Shady Grove

Request for changes to the approved development plans

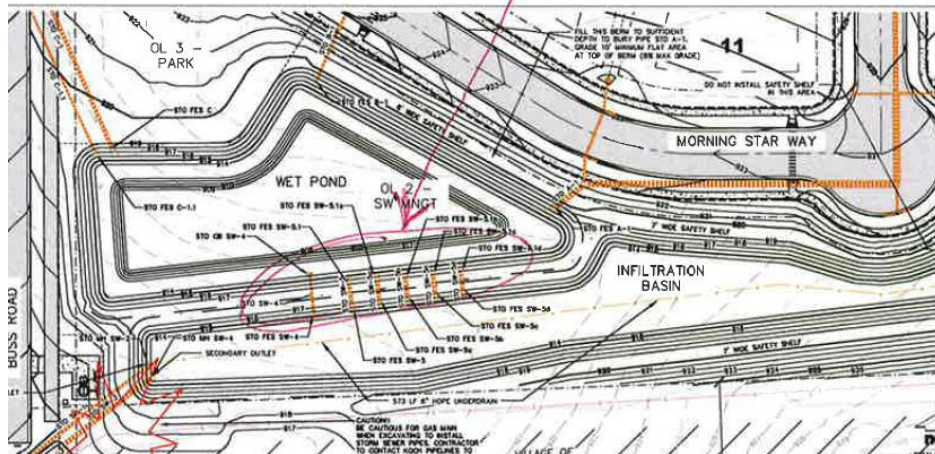
1. Change from 4" to 3.5" asphalt on side streets.
 - Drumlin, Shady Street, Fundamental Way, Morning star Way, Max Kolbe Circle are side streets with minimal traffic as they are not arterial roads.
 - We understand there is precedence for this existing in the Village.
 - Buss Road to remain 4"
2. Reduce gravel depth from 12" to 10" on side streets
 - Drumlin, Shady Street, Fundamental Way, Morning star Way, Max Kolbe Circle are side streets with minimal traffic as they are not arterial roads.
 - We understand there is precedence for this existing in the Village and proof rolls are required to assure a stable base.
 - Buss Road to remain at 12"
3. Eliminate pond pipe overflows
 - Remove these pipes

Remove these pipe

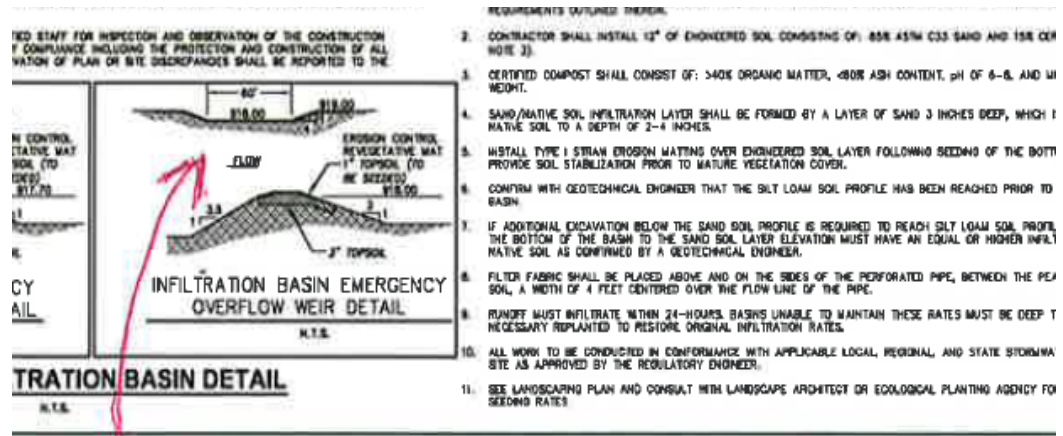
- Replace with overflow similar to this

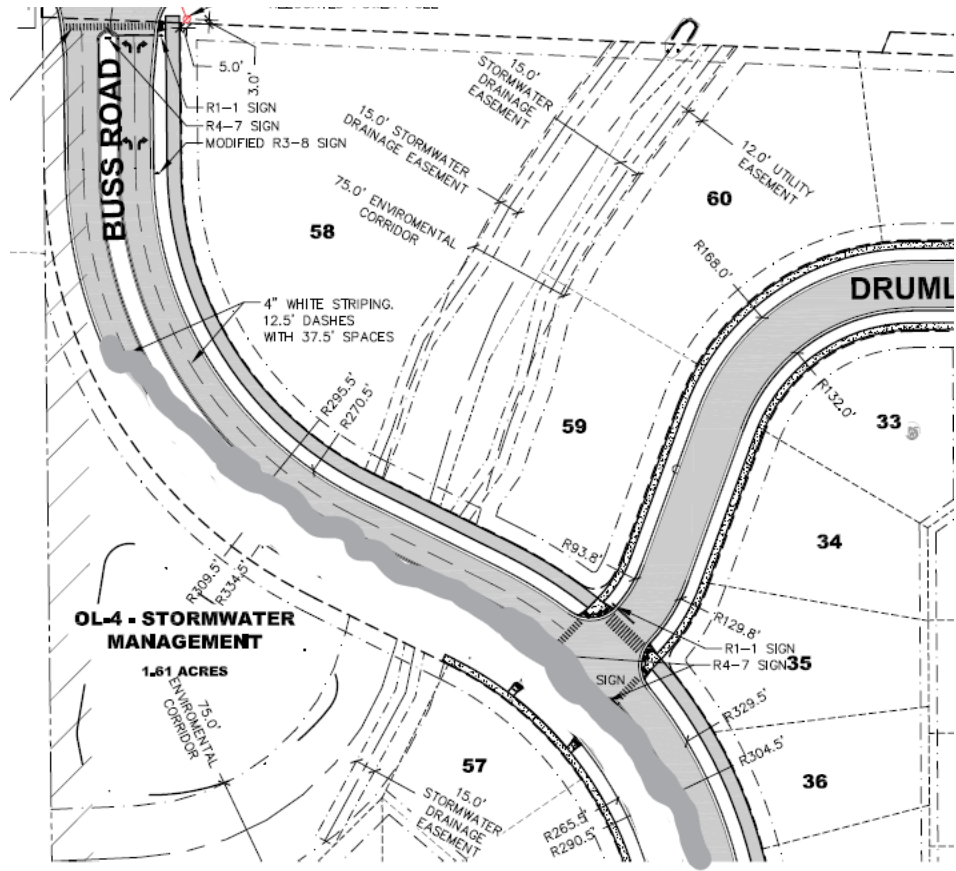
Replace with
overflow similar to this

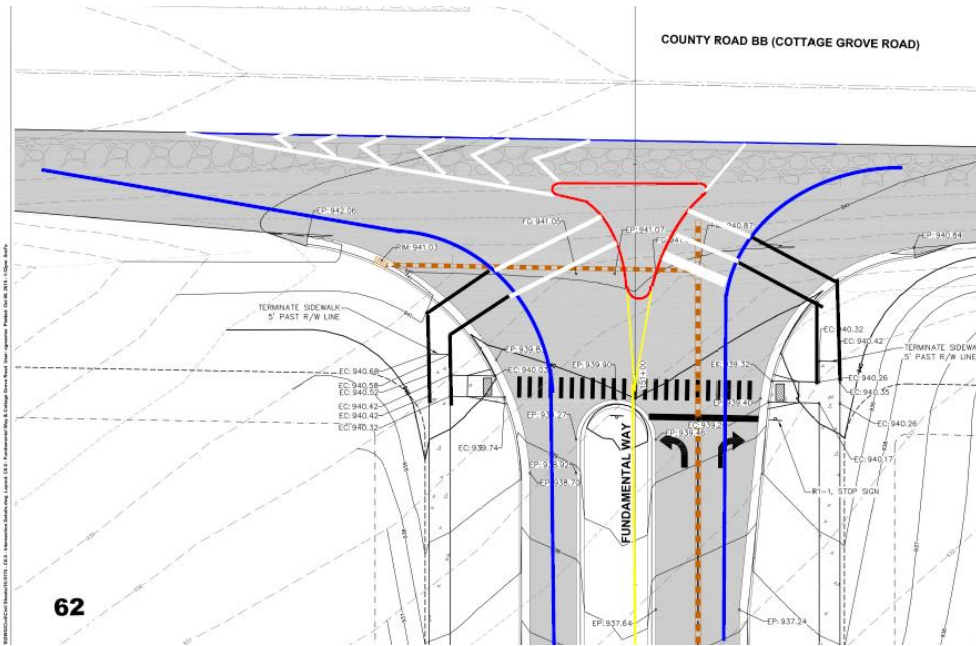
- Rework East entrance to development to be right in, right out to deter traffic to use the lighted intersection. See sketch below.
